**PCN# : P4B9AAB**  
**Issue Date : Feb. 12, 2015**

**DESIGN/PROCESS CHANGE NOTIFICATION**

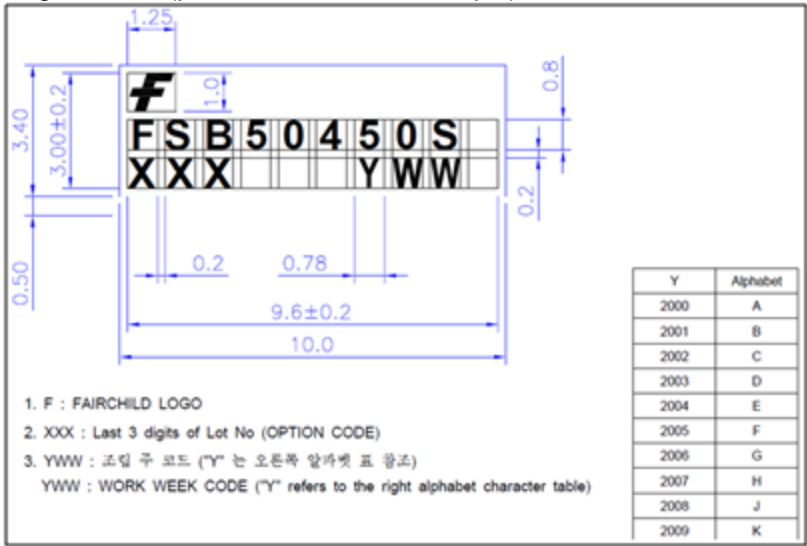
Description of Change (From) :

Single manufacturing source location at Suzhou  
Original mark (put FSB50450S as example)

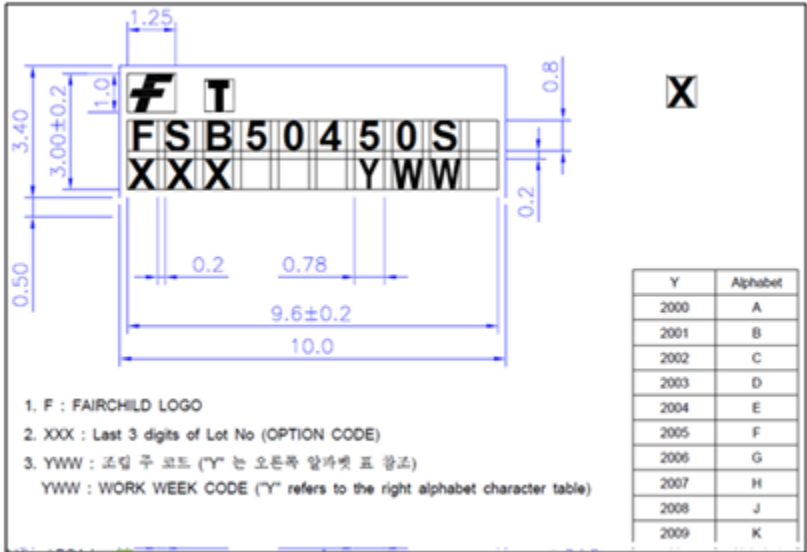
Description of Change (To) :  
Additional manufacturing source location at Taiwan  
Mark change to below with plant code 'T' after Fairchild logo 'F'. 'T' size and font same as below device name.
